# UNITED STATES PATENT AND TRADEMARK OFFICE

APPLICATION NO.	FILING DATE	FIRST NAMED INVENTOR	ATTORNEY DOCKET NO.	CONFIRMATION NO.
10/552,875	10/13/2005	Niki S. Woodhead	20410/0203396-US0	9177
7278	7590	06/23/2009	EXAMINER	
DARBY & DARBY P.C. P.O. BOX 770 Church Street Station New York, NY 10008-0770			GARCIA, ERNESTO	
			ART UNIT	PAPER NUMBER
			3679	
			MAIL DATE	DELIVERY MODE
			06/23/2009	PAPER

<b>Office Action Summary</b>	<b>Application No.</b>	<b>Applicant(s)</b>
	10/552,875	WOODHEAD ET AL.
	<b>Examiner</b>	<b>Art Unit</b>
	ERNESTO GARCIA	3679

FIG. 2

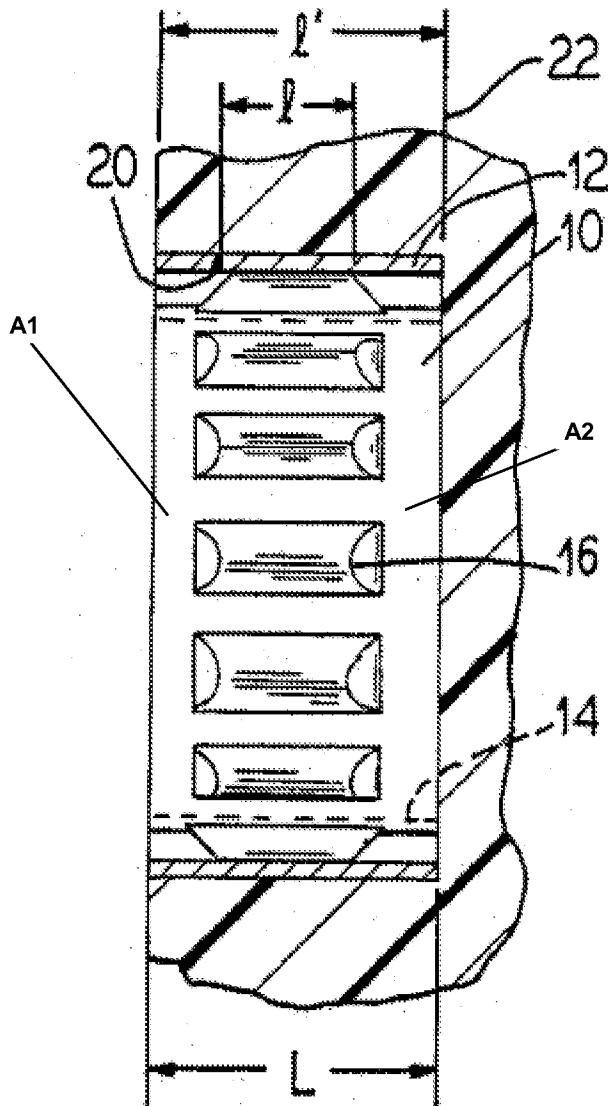
Regarding claim 1, Cramer, Jr. et al. disclose, in Figures 1 and 2, a tolerance ring comprising a band **10** of resilient material. The band **10** has a plurality of protrusions **16** formed therein. All of the protrusions **16** extend radially between unformed annular portions **A1**, **A2** of the band (see marked-up attachment). The corrugated protrusions **16** form a protrusion load bearing area. The unformed annular portions **A1**, **A2** form unformed annular portion load bearing area. The unformed annular portions **A1**, **A2** include an endmost unformed annular portion **A1**. However, Cramer, Jr. et al. fail to disclose a guide portion being contiguous with and extends axially and radially outward from the endmost unformed annular portion **A1**; the guide portion comprises at least one guide surface contiguous with the unformed annular portion load bearing area and inclined relative to an axis of the band **10** in the same radial direction as the protrusion; and a free end of the guide portion defining an opening larger than that defined by the unformed annular portions **A1**, **A2** of the band **16**, and the free end defining a diameter that is not greater than the diameter of the protrusions.

Regarding claim 8, Cramer, Jr. et al. disclose, in Figures 1 and 2, a tolerance ring comprising an annular band **10** of resilient material having an innermost surface and an outermost surface. The innermost surface is defined by unformed annular portions and the outermost surface is defined by radial protrusions **16** formed in the annular band. Each protrusion **16** extends radially outward between a pair of the unformed annular portions **A1, A2**. However, Cramer, Jr. et al. fail to disclose a guide portion at one end of the annular band and being contiguous with and extends axially from an endmost unformed annular portion and comprising a guide surface which is contiguous with and flares outwardly from the innermost surface, and the guide portion extending from a whole circumference of the band.

Regarding claim 21, Cramer, Jr. et al. disclose, in Figures 1 and 2, a tolerance ring comprising an annular band **10** of resilient material having an innermost surface defined by a plurality of unformed annular portions **A1**, **A2** and an outermost surface defined by a plurality of radial protrusions **16** formed in the annular band **10**. The radial protrusions have a diameter. Each protrusion **16** extends radially outward between a pair of the unformed annular portions **A1**, **A2**. However, Cramer, Jr. et al. fail to disclose a guide portion, at one end of the annular band, being contiguous with and extending axially and radially outward from one of the unformed annular portions, and comprising a guide surface which is contiguous with and flares outwardly from the innermost surface, and the guide portion having a free end defining an opening that has a diameter not greater than the diameter of the unformed annular portions.
